Service Information

Published by
The M.G. Car Company Ltd.
Abingdon-on-Thames

INDEX (Sheet 1)

Service Information Sheet No. 3**GEARBOX OIL LEAKAGE FROM LAYSHAFT**

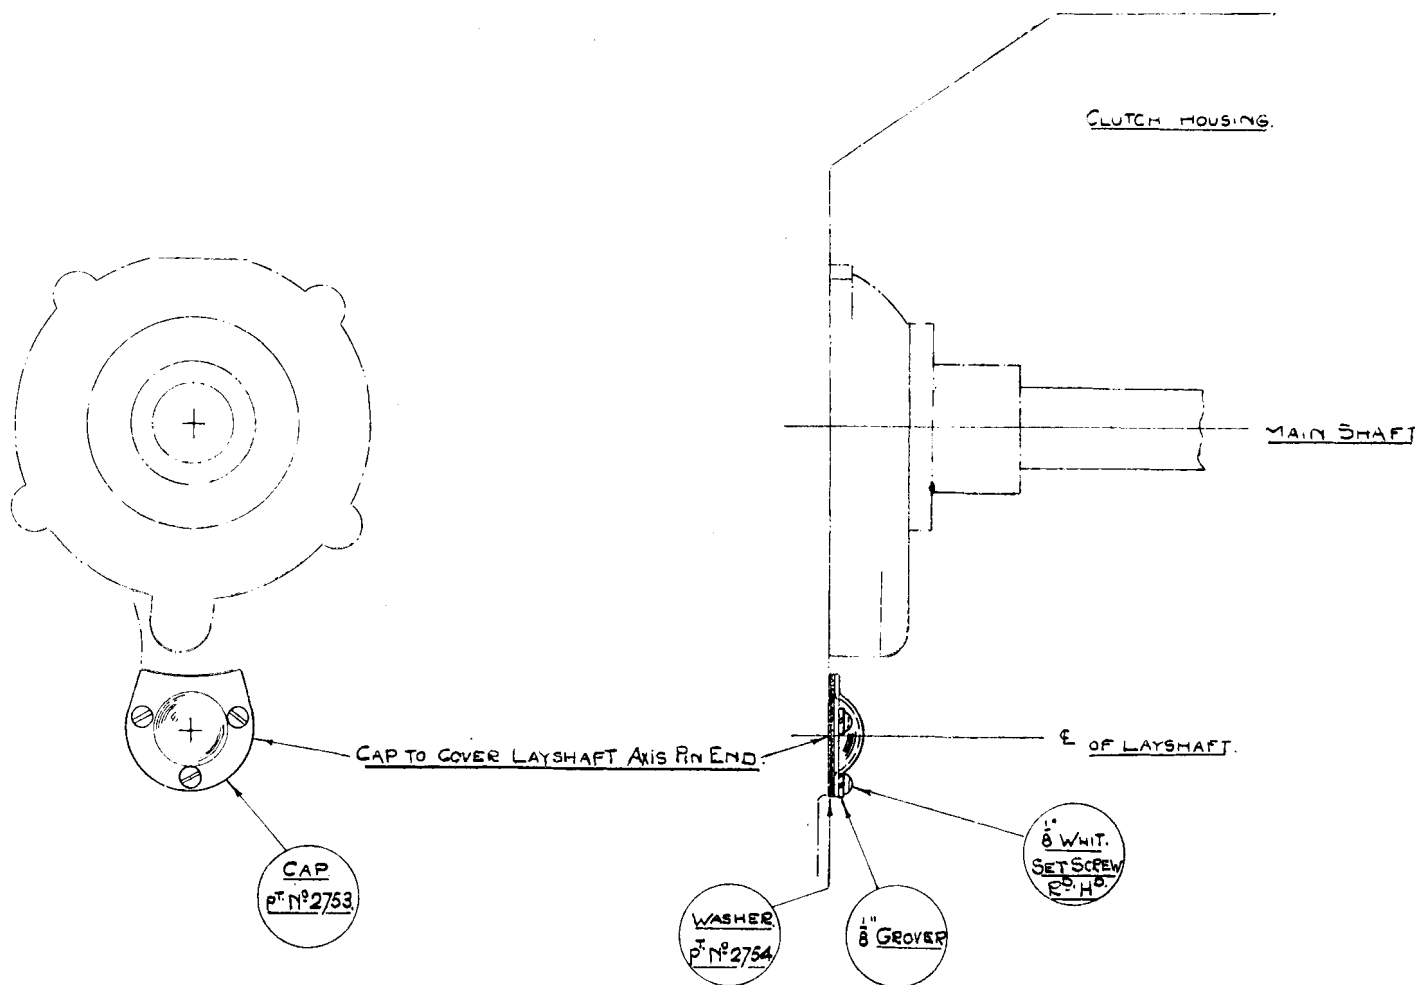
This trouble is not very prevalent, but when it is found a small cover fitted with a washer and three screws can be fitted to prevent a recurrence.

The drawing herewith (Service Blue Print No. 147) gives particulars of the cover, screws and washer, and also shows its location on the gearbox.

Service Information Sheet No. 5**GEAR LEVER RATTLE**

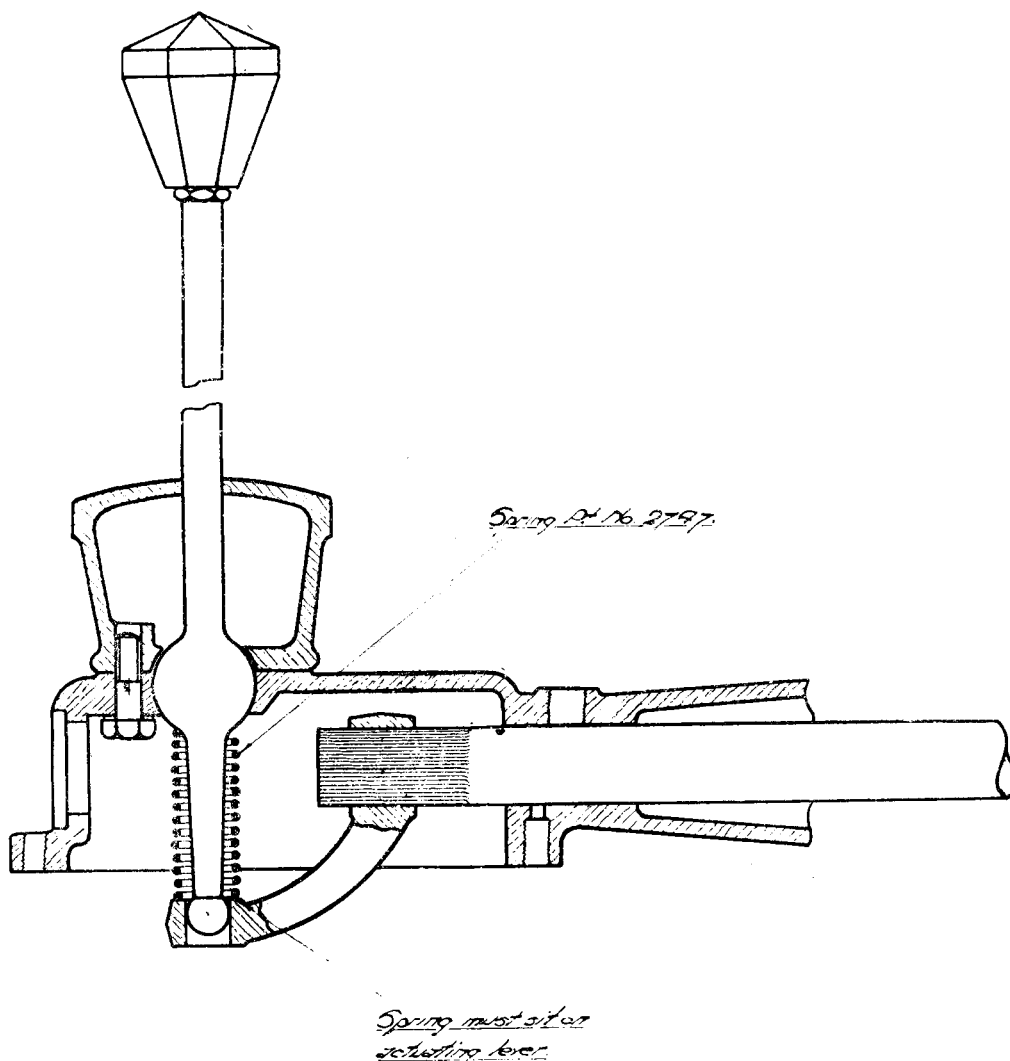
Complaints of rattle in the gear change remote controls have been made from time to time, and up till recently no very satisfactory cure has existed.

It has been found that a spring fitted as shown in the drawing (Service Blue Print No. 146) prevents rattle most effectively.

The Part Number of the spring in question is 2747, and this number, together with the Chassis Number of the car concerned, must be quoted when ordering for service.

Service Information Sheet No. 19**WATER PUMP**

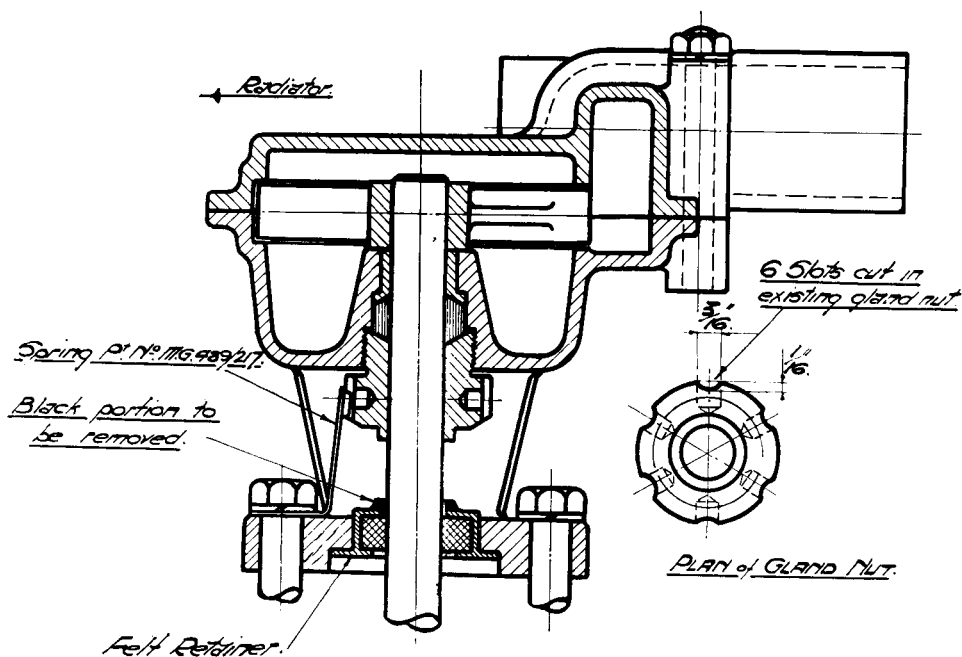
This modification is very simple to carry out on all existing pumps.

The existing gland nut is slotted to receive the new spring.

The coil spring spigot is removed from the spindle felt retainer.

Service Information Sheet No. 24**CLUTCH MODIFICATIONS**

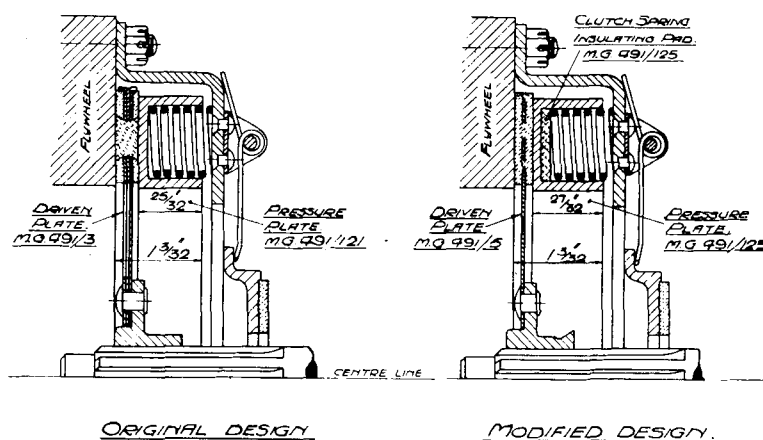
A lighter design of driven plate, with a proportionately thicker pressure plate, has been incorporated in the P. and N. Type clutch.

The sketch given below of the original and modified design of clutch will illustrate this point.

The modified design of clutch consists of a driven plate having a single disc with the lining moulded in position, the pressure plate being $\frac{27}{32}$ in. thick. Insulating pads are inserted in the spring guide holes to protect the clutch springs from heat.

MAGNETO DRIVE

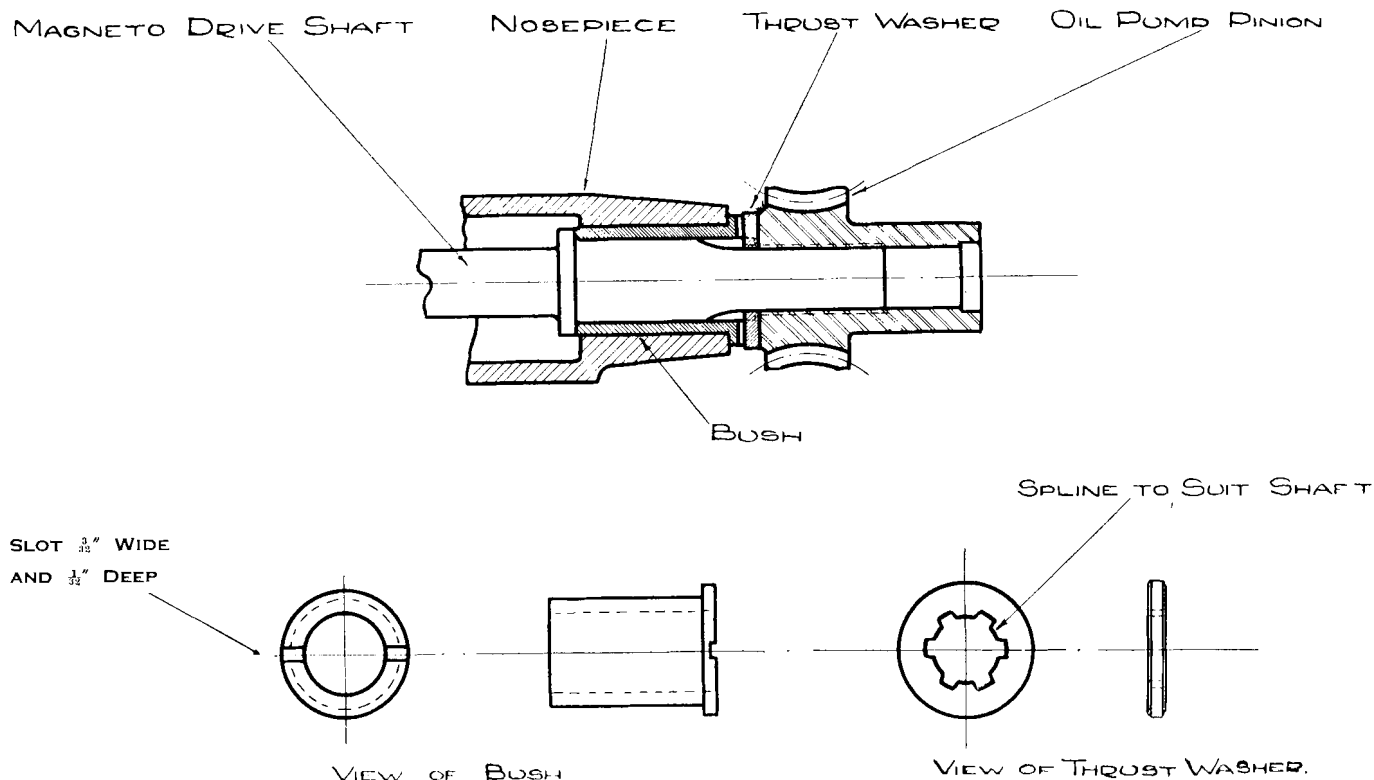
It has been found that the magneto drive thrust washer has been cutting into the splined shaft, causing it ultimately to fail.

Immediate action is necessary to obviate this, and the present washer is to be replaced by a modified one, as shown in the sketch, the washer being splined to the shaft. As the new type of washer has plain faces, oil grooves must be cut in the face of the bush to dimensions as shown in the drawing.

The modified washer (Part No. MG.348/298) and splined shaft (Part No. MG.348/227) may be obtained on application being made to the Claims Department.

Service Information Sheet No. 29**CLUTCH OPERATING DISC SPRING**

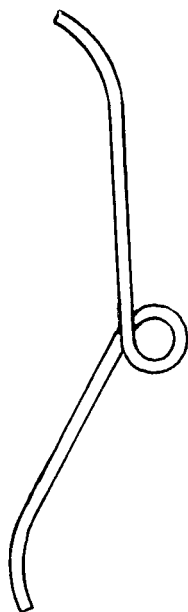
As a result of a few complaints of failure of clutch operating disc springs, it has been decided to discontinue the use of the springs to Part No. MG.412/116 and to substitute three more springs to Part No. MG.412/115, all six springs thereby being of the same type.

Replacement springs may be obtained in exchange for the obsolete springs on application being made to our Claims Department.

Service Information Sheet No. 39**LOCKHEED BRAKE PIPE LINE**

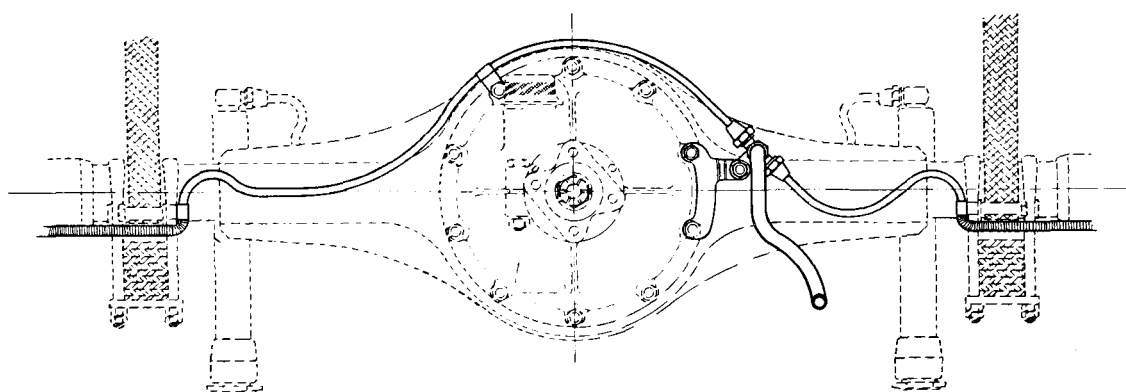
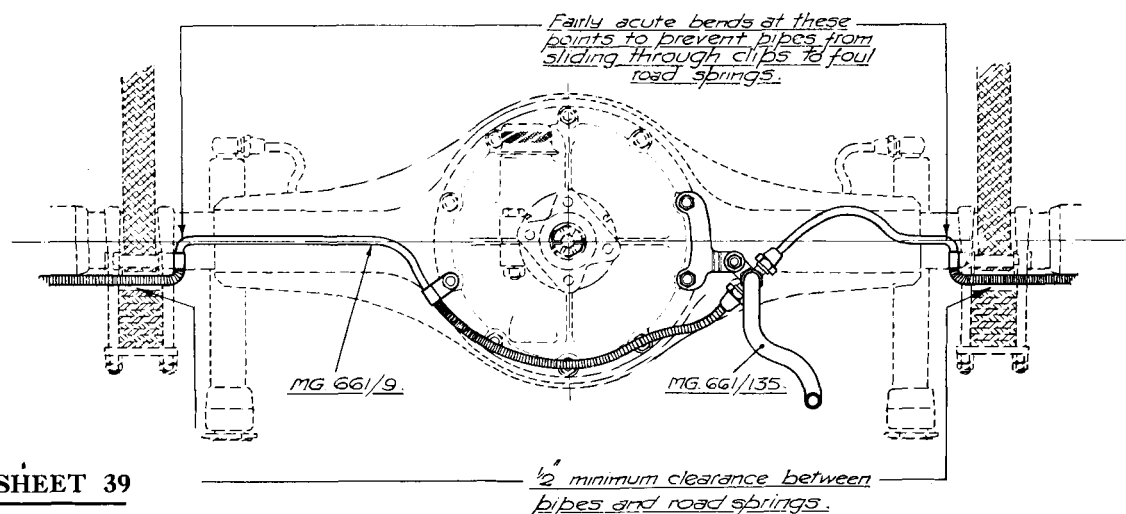
A modification therefore is vitally necessary and consists of reversing the bracket bolted to the rear axle nose piece carrying the "T" piece, also turning the "T" piece into a position when the outlet connections are nearer to the ground.

The sketch illustrates the modification.

Service Information Sheet No. 40**BRAKE CABLES**

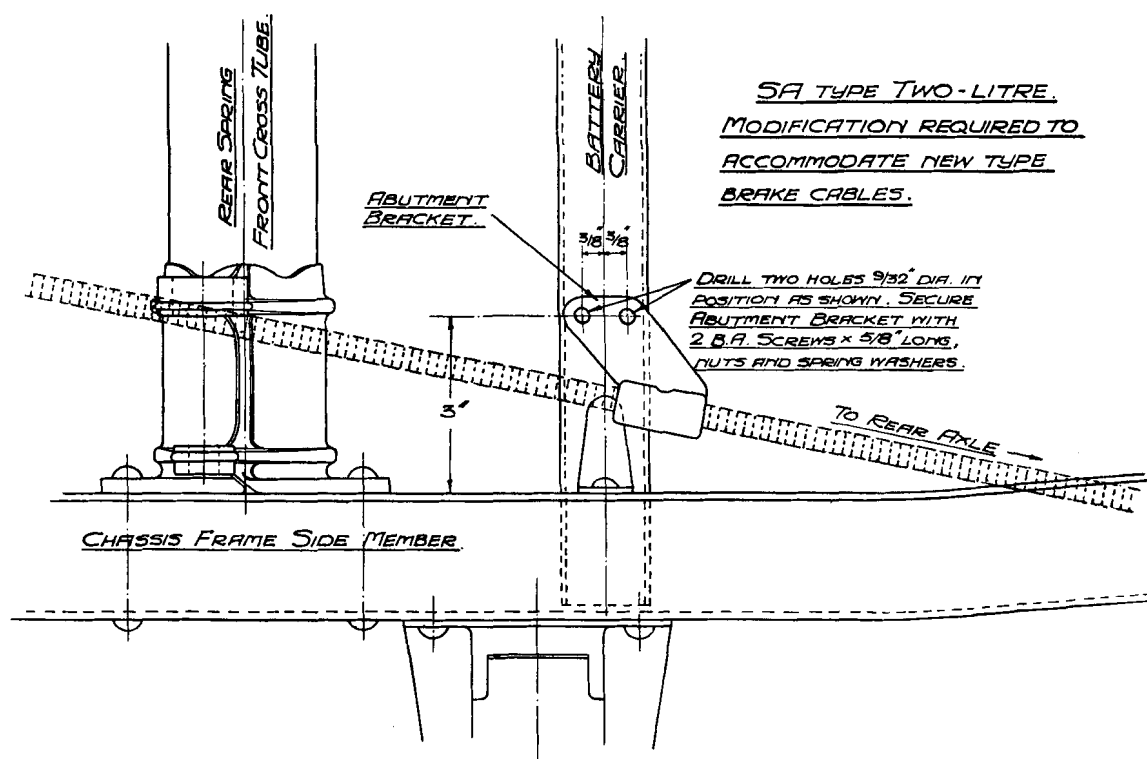
An improved design of brake cable to Part Nos. MG661/26 O/S and MG661/27 N/S, has been introduced on the S.A. Type Two-litre model, commencing at Chassis No. SA1407.

These new cables have been designed to operate through approximately a straight run from the hand brake cross shaft to the rear back plates, when assembled. This feature has necessarily led to the re-positioning of the brake cable abutment brackets.

On cars bearing a Chassis Number previous to SA1407, to accommodate the new cables, it will be necessary to drill two $\frac{9}{32}$ in. diameter holes in the battery carrier to secure each of the abutment brackets. Particulars of this modification are given in the sketch below. The cables being fitted, it only becomes necessary to connect the Tecalet pipe line to the abutment bracket when the work is complete.

Service Information Sheet No. 51**MODIFICATIONS FOR IMPROVED VENTILATION AND CONTROL OF TEMPERATURE**

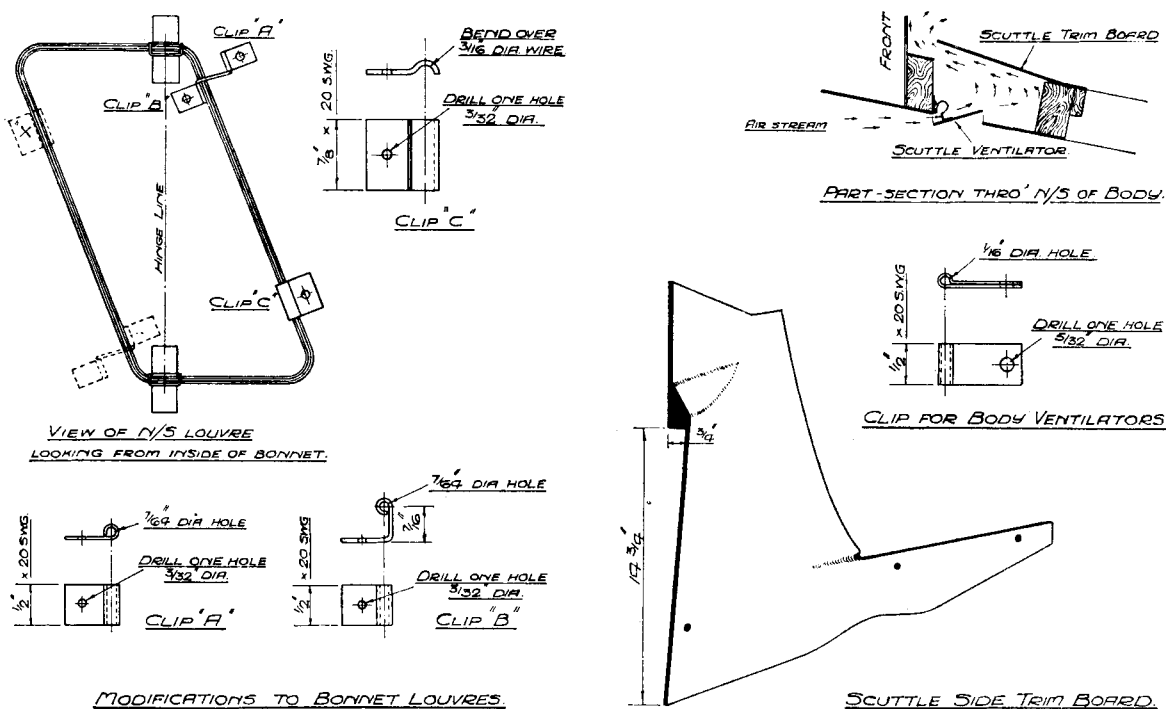
In order to improve ventilation and for a more satisfactory control of temperature in the body interior, certain modifications have been incorporated on production. Details of similar modifications are given herewith, for the conversion of earlier cars, if required.

The front two louvres are to open forward instead of backward as previously. Taking each louvre individually, the existing stop clip marked "X" on the illustration need not be removed, but should be bent back toward the bonnet and flattened out. The spring clips can remain, but the spring is removed for further use, as explained below.

The side trim boards will require to be modified in order that in-rushing air is diverted to the front of the scuttle, not only to prevent draught but to give better ventilation. This is illustrated in the view showing a part-section through the near-side of the body.

*Date of Issue : July, 1938***Service Information Sheet No. 54****SHOCK ABSORBER RIDE CONTROL PUMP**

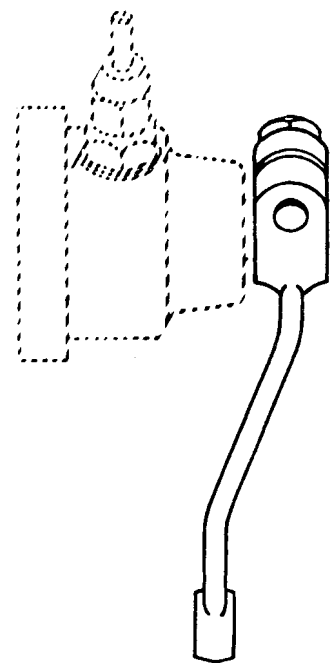
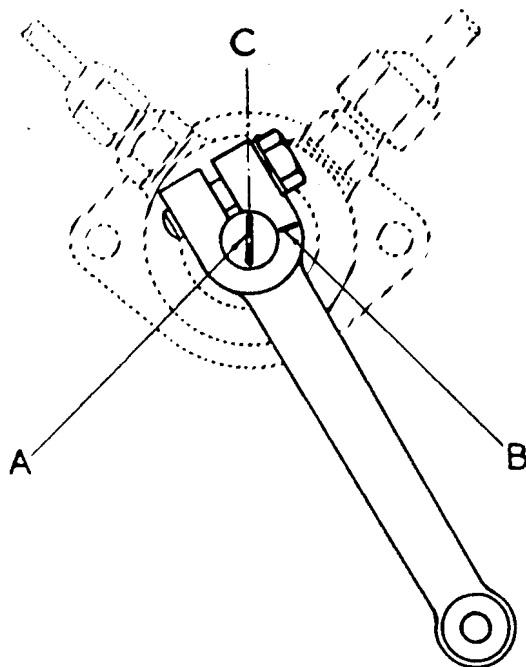
To overcome this difficulty the lever pinch bolt must be slackened and the lever turned clockwise on the shaft until the mark "A" on the shaft lines up with the corner of the lever boss as shown at "C."

This is a very small but very important modification and all Service Stations are requested to check and readjust the pump units on all 1½ Litre (VA. Type) cars that are in for service.

CHASSIS DIMENSIONAL DRAWING

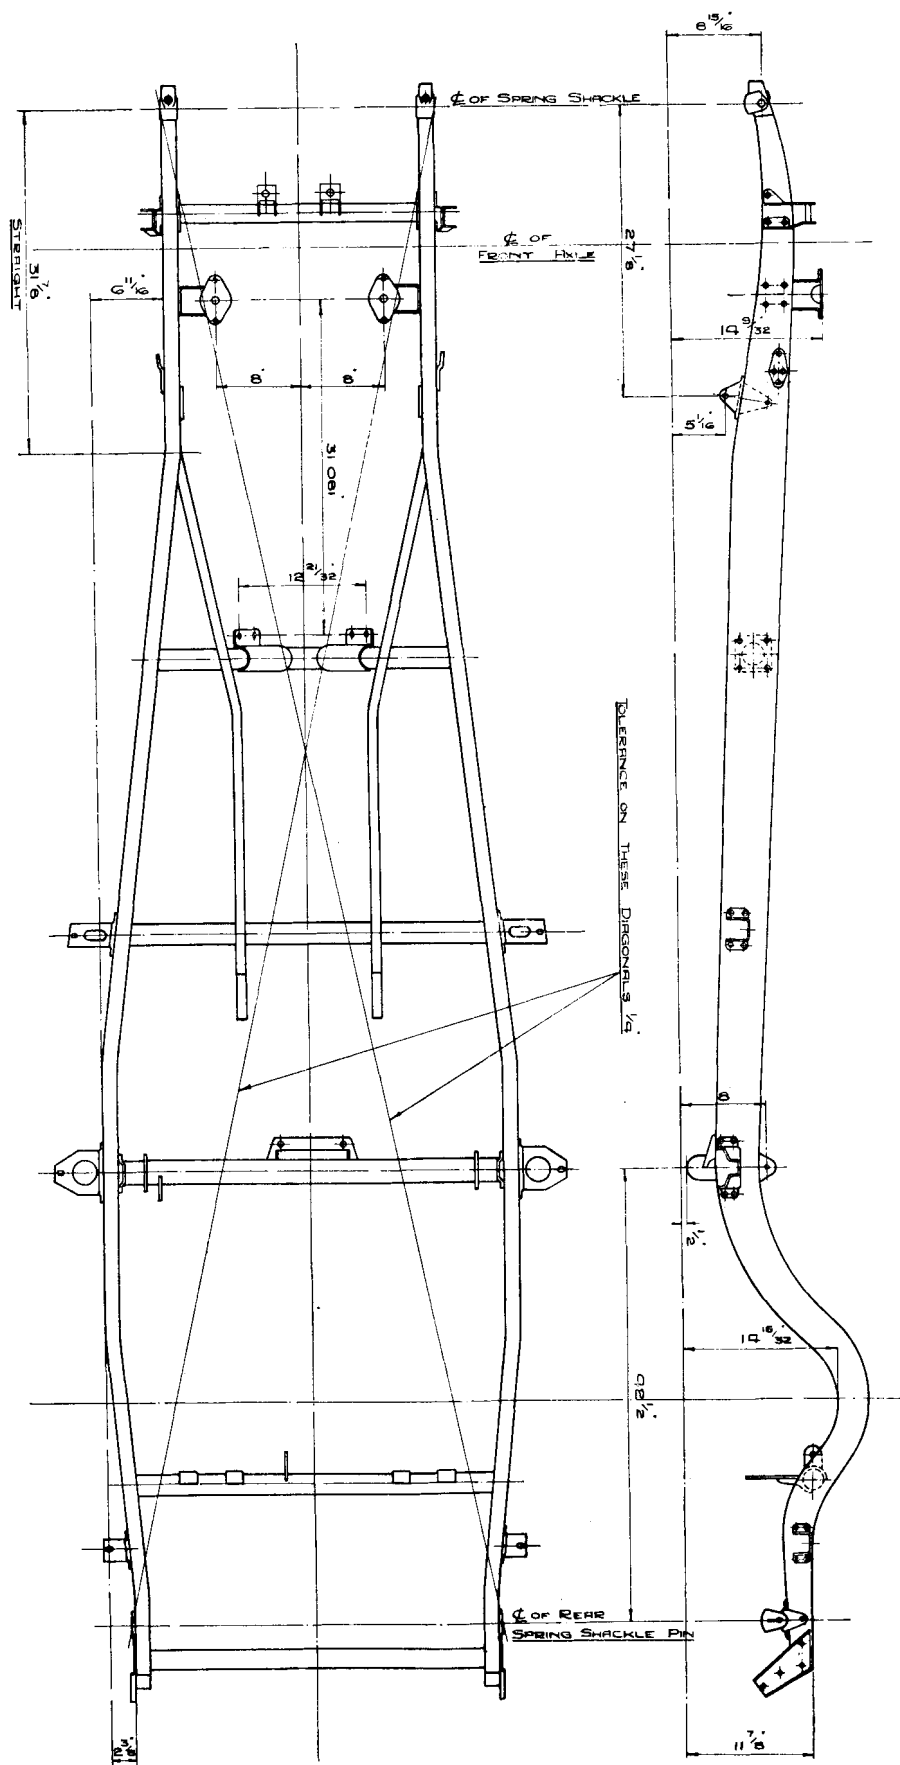
It has been pointed out that the Chassis Dimensional Diagram at present appearing in the Instruction Manual for the 1½-Litre VA. Type is inaccurate. The discrepancies have now been rectified and the correct diagram is given below.
